Addendum Number One
To The Drawings and Specifications for
RFB #14-0091, Lake Afton, Package One, Issue Two

Issued: Tuesday, September 23, 2014

HANNEY & ASSOCIATES ARCHITECTS
1726 South Hillside, Wichita, Kansas

1 ADDENDUM I
AREA 5 - SHELTER I

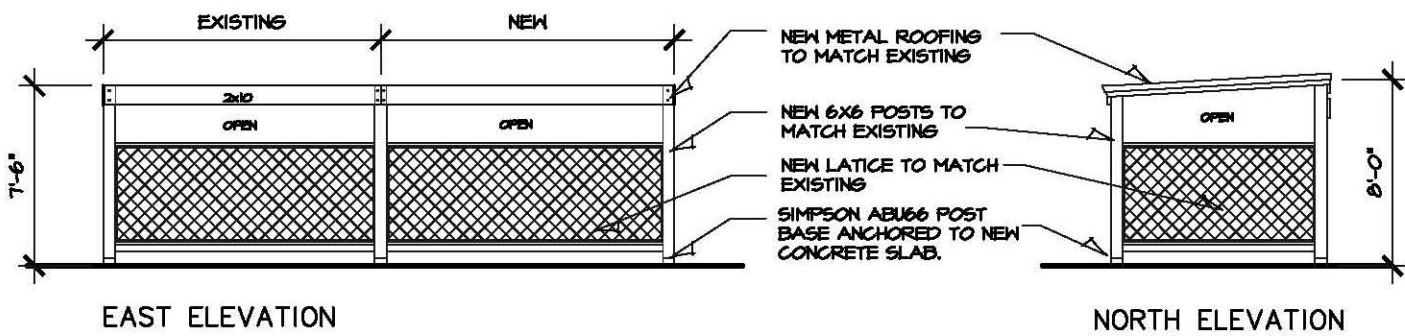
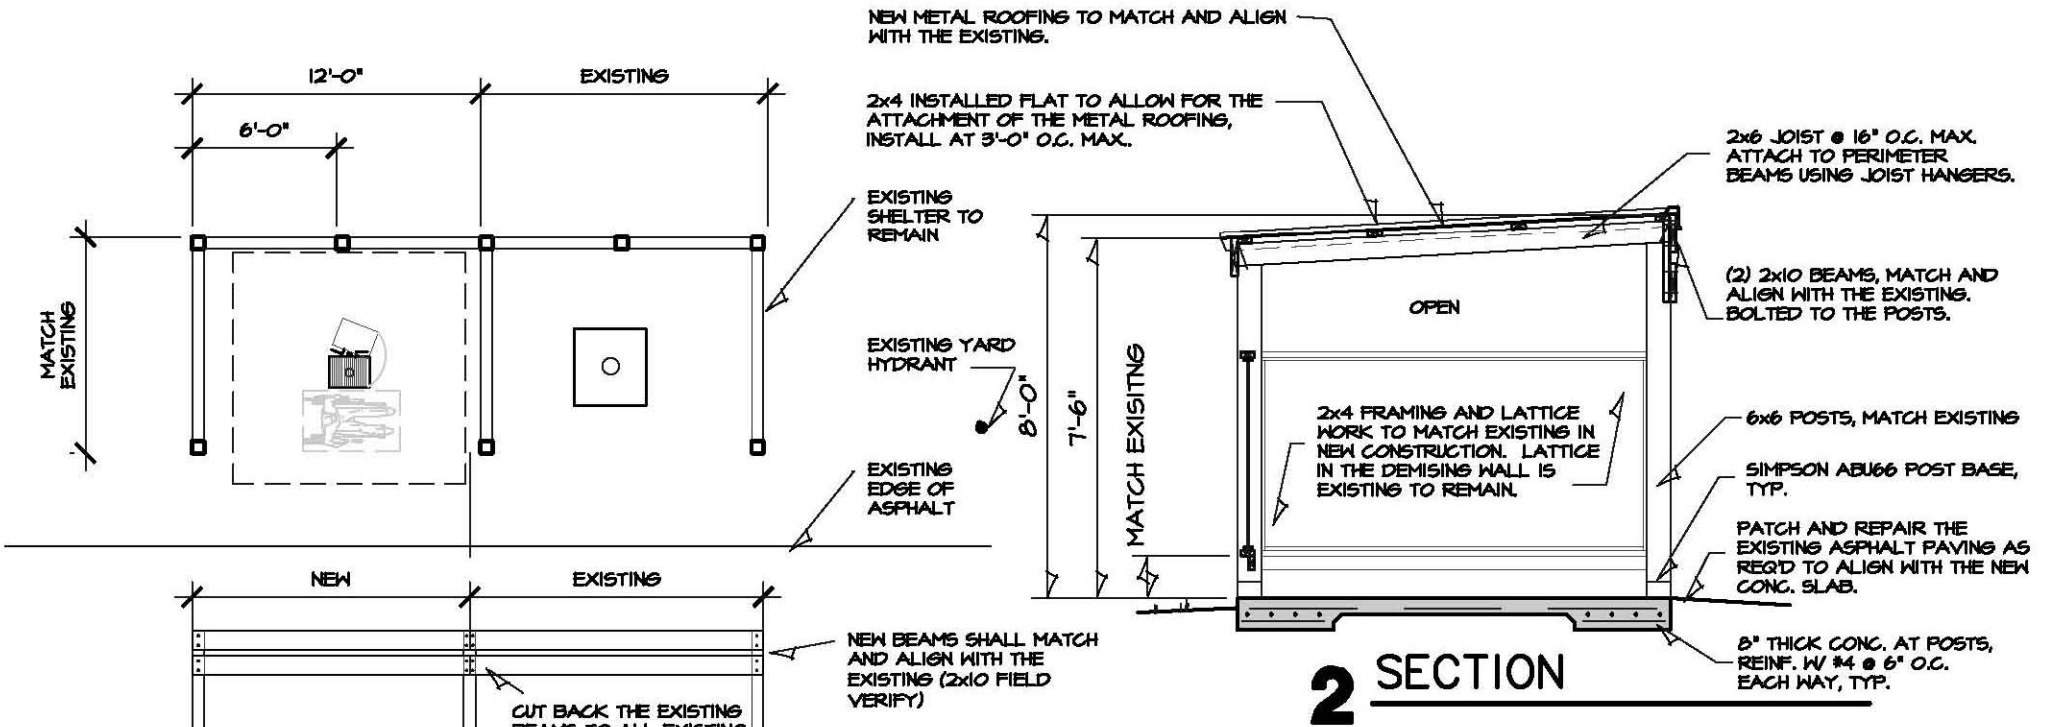
- 2.1.1 New Accessible Outdoor Grille
- a. There is an existing yard hydrant that would be located within the new concrete slab placed for the new grille. The yard hydrant will remain; the accessible grille shall be relocated to the north side of the existing grille.

- b. The enclosure for the new accessible grille is to match the existing.
 - c. The posts shall be clarified to be 6 x 6 anchored to the slab using Simpson ABU66 post bases. The concrete shall be thickened at the posts to 8” thick x 2’ x 2’ area. Reinforce the 2’ square post areas with #4 rebar at 6” spacing each way. The post height shall match the existing.

- d. The walls of the new enclosure shall match the existing – 2x4 framing with lattice.
 - e. The roofing and roof framing shall match the existing. The beams shall attach to the existing north wood columns (posts) using anchor bolts and washers. Attachment to the existing posts will require cutting back the ends of the existing beams (North side) and re-anchoring the bolts in a new location south of the centerline.
